Barangaroo Stage 1B Public Domain

*State Significant
Development
Modification Assessment
(SSD 7944 MOD 1)*

October 2019

Figure 10 | A site plan of the interim design solution for the interface between Hickson Road and Hickson Park
(Source: Applicant)

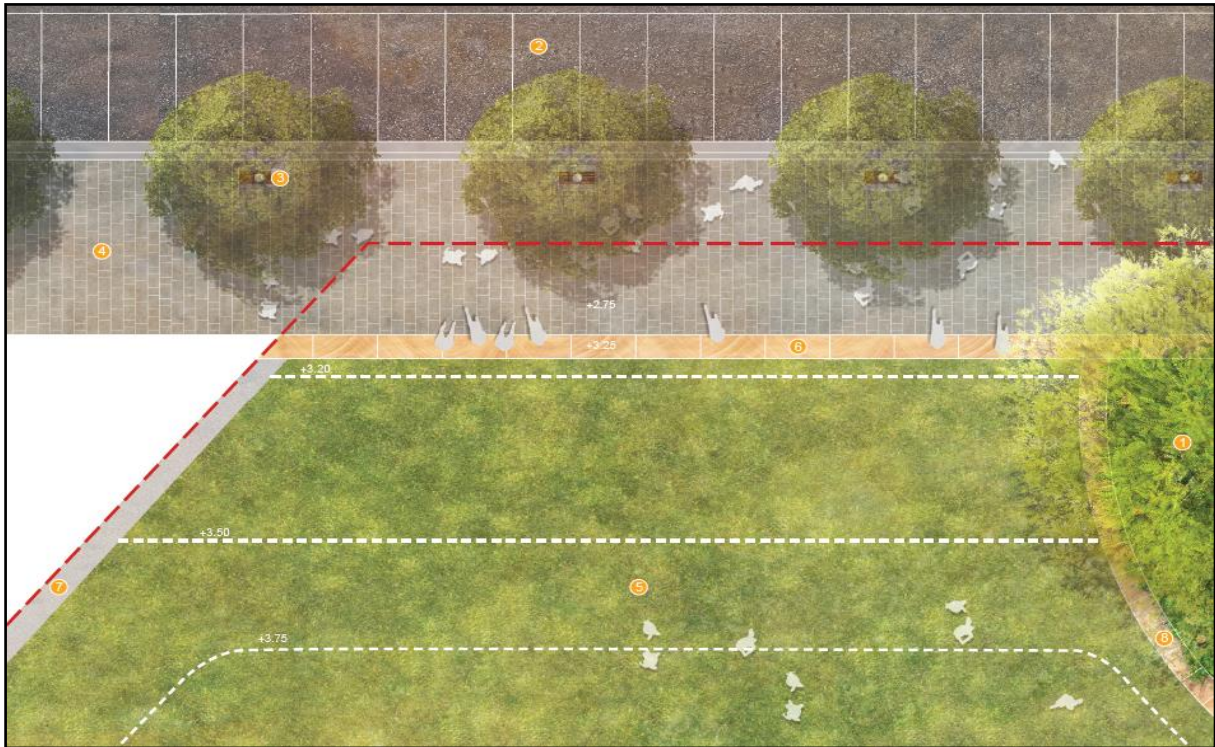
Until Hickson Road is raised, the Applicant is proposing an interim design solution to manage its interface with Hickson Park (**Figure 10**). The interim solution proposes a low, 500 mm sandstone block wall to Hickson Road. The temporary solution will ensure the park will be developed to comply with the required deep soil volumes and be maintained until final road levels are constructed. Once Hickson Road is raised, the interim design solution will be removed, and a permanent design solution will be developed by Infrastructure NSW.

Council also requested the Applicant produce a Public Domain Plan in consultation with its Public Domain Unit to focus on the footways and interfaces with Hickson Road. The Applicant noted Infrastructure NSW is responsible for the design and construction of Hickson Road (including the footways that adjoin to Hickson Park) and will consult with Council during the planning process.

The Applicant advised the proposed levels at Hickson Park on the eastern edge were nominated by Infrastructure NSW to meet the raised levels of Hickson Road in the future. Consequently, the Applicant considers a temporary wall is required in this location due to the substantial difference between the proposed level of Hickson Park and the current level of Hickson Road. The Applicant notes Hickson Park will still remain

The Department considers raising the level of Hickson Park is acceptable as it would allow the park to integrate with the future upgrade of Hickson Road. The Department also notes the raised levels will assist with stormwater management and supports the improved embellishment and enhancement of the public domain by maintaining minimum soil depths.

Figure 12 | Deletion of precast concrete seats/bollards on eastern edge of Hickson Park (Source: Applicant)

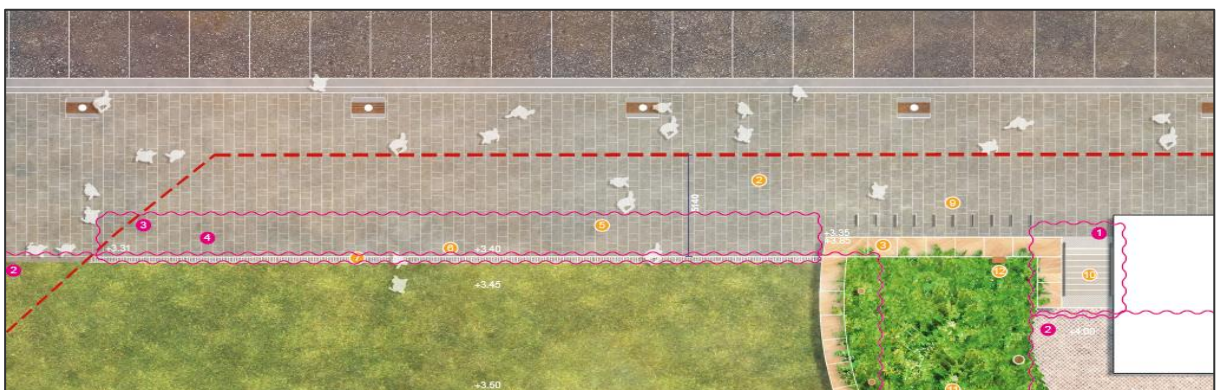
The original modification application sought to change the proposed sandstone bollards on the eastern and western edges of Hickson Park to precast concrete (**Figures 11 & 12**).

Council raised concerns the change of material to precast concrete will have little design finesse and the Applicant had not provided a justification for the reduction in quality of material, from sandstone to precast concrete.

The Applicant also seeks to increase the spacing between the concrete seats/bollards on the western edge of Hickson Park by at least 1.2m in appropriate places (**Figure 11**). The Applicant notes this change would accommodate prams and wheelchairs and promote pedestrian accessibility into Hickson Park. The Applicant also notes the concrete seats/bollards on the eastern edge will be removed and any permanent seats/bollards will be implemented by Infrastructure NSW during the Hickson Road upgrade (**Figure 12**).

The Applicant noted the change in material was required to better complement the paving (in grey tones) and strip drain, to increase long-term durability, reduce ongoing maintenance and ensure a high-quality appearance is maintained. Council subsequently reviewed the Applicant's RtS and accepted the proposed changes.

The Department considers the change of material to precast concrete to be acceptable due to the long-term benefits for the public domain including improved appearance, less ongoing maintenance and greater durability.

Figure 15 | The proposed pier at Watermans Cove (Source: Applicant)

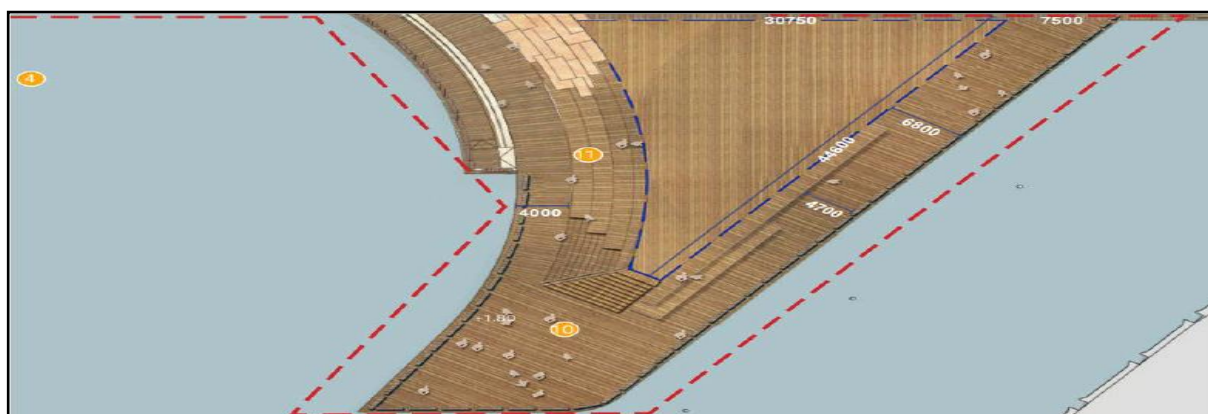
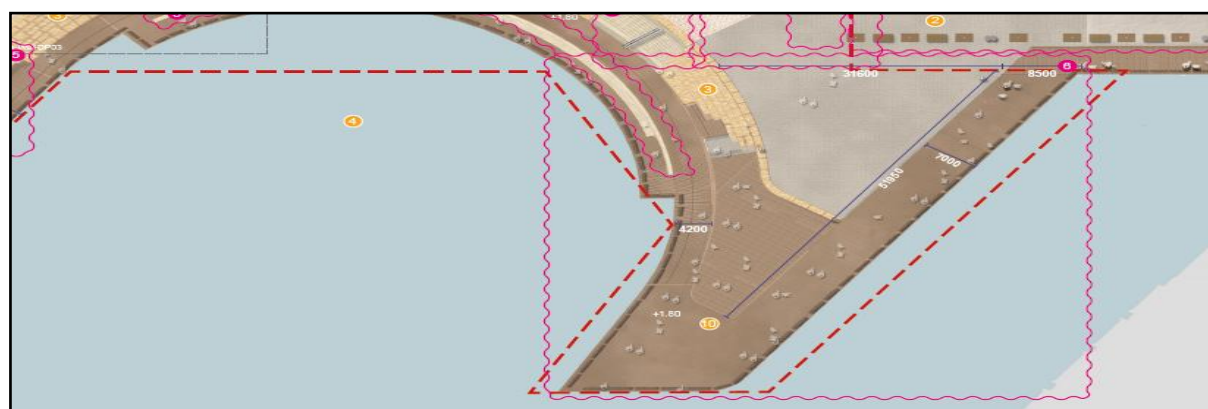
The public pier at Watermans Cove was approved with two tiers and integrated seating (**Figure 14**). Following a process of design refinement, the Applicant proposes the number of tiers be increased from two to three and the surface material of the upper tier changed from timber to hard paving (stone) (**Figure 15**).

The amendment to the number of tiers and hard paved upper level will assist with facilitating a range of events and activities in the future. The Applicant notes the overall envelope and extent of the pier over the Harbour is not proposed to change.

Figure 16 | Proposed removal of timber seating from raised planter in Watermans Quay identified as 1 (Source: Applicant)

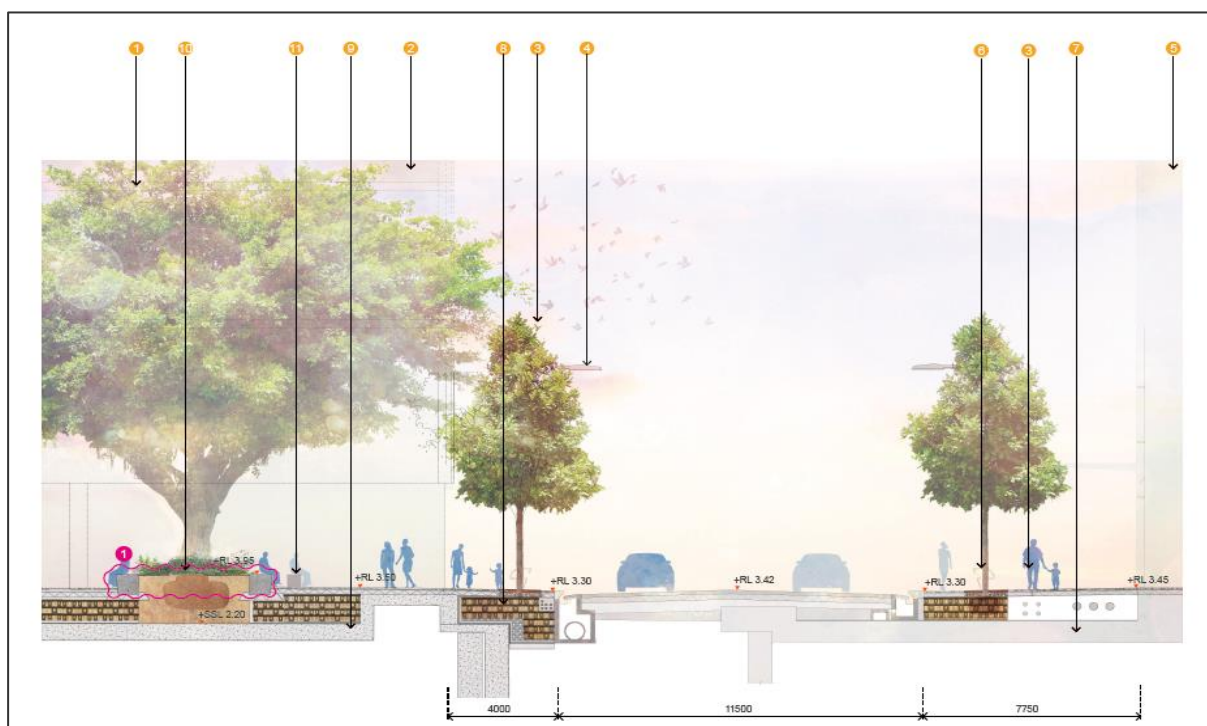
The modification also proposes to remove the porphyry paving and replace with the City of Sydney transition paving as per Condition B23 of the consent, minor bollard realignment and removal of timber top from Watermans Quay raised planter seating.

Council was originally concerned with the deletion of timber seating in Watermans Quay, noting the Applicant had not provided an alternative design with comfort in mind and no details of the planter design have been provided.

In the RtS, the Applicant responded to Council's concerns noting the change of timber seating to precast concrete was due to concerns the collection of debris from the canopy of fig trees above would negatively impact the day-to-day aesthetic. Council subsequently reviewed the Applicant's RtS and noted its issues had been addressed.

The Department considers the change of material to precast concrete to be an adequate mitigation strategy to protect the seating from debris and will improve the overall amenity of the public domain at Watermans Quay.

Figure 17 | Proposed removal of porphyry paving on Wulugul Walk identified as number 1 (Source: Applicant)

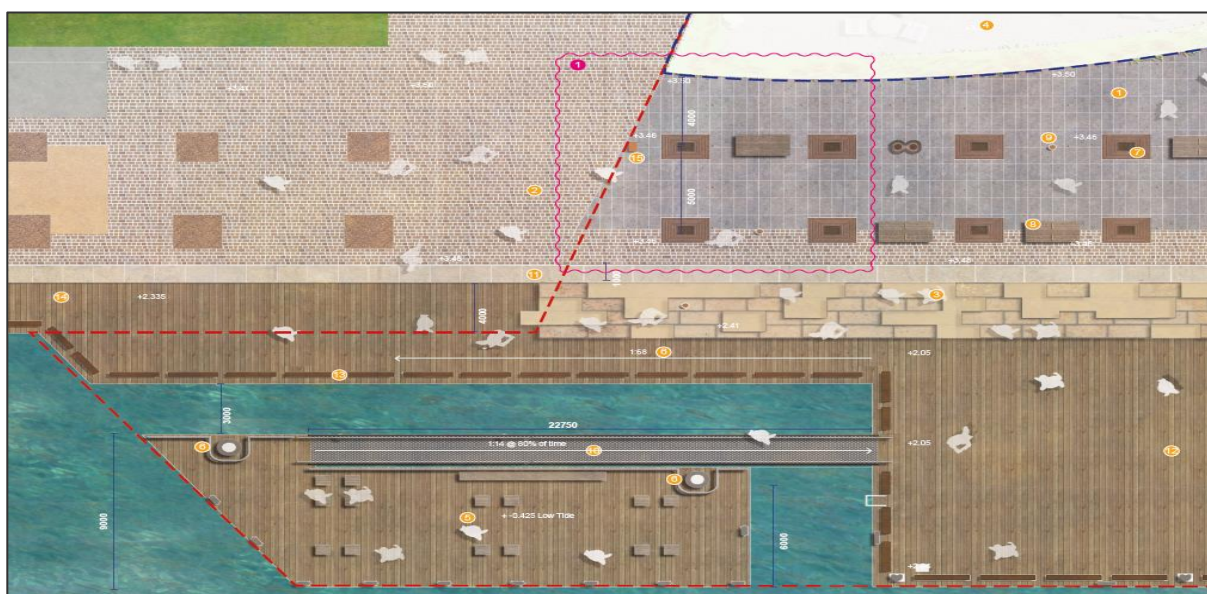
The modification seeks to make design and aesthetic changes to Wulugul Walk, including the removal of the porphyry paving that interfaces with Barangaroo Stage 1A and Barangaroo Central, and change to the Wulugul Walk granite paver. The Applicant proposes drainage grates to be removed along the porphyry band in Wulugul Walk and paving and tree pits are to be changed to match Barangaroo South Stage 1A public domain.

The modification also seeks to change the sandstone fascia design to the western side of the Spirit of Tasmania Landing, change the brass handrails to bronze, and update power point and water point locations.

The Department considers the modifications to porphyry paving, the sandstone fascia design and change of materials for the handrails located at Wulugul Walk to be minor and will ultimately provide consistency with the Stage 1A public domain. The Department notes the modifications will provide public benefit and improve the overall design and functionality of the site.
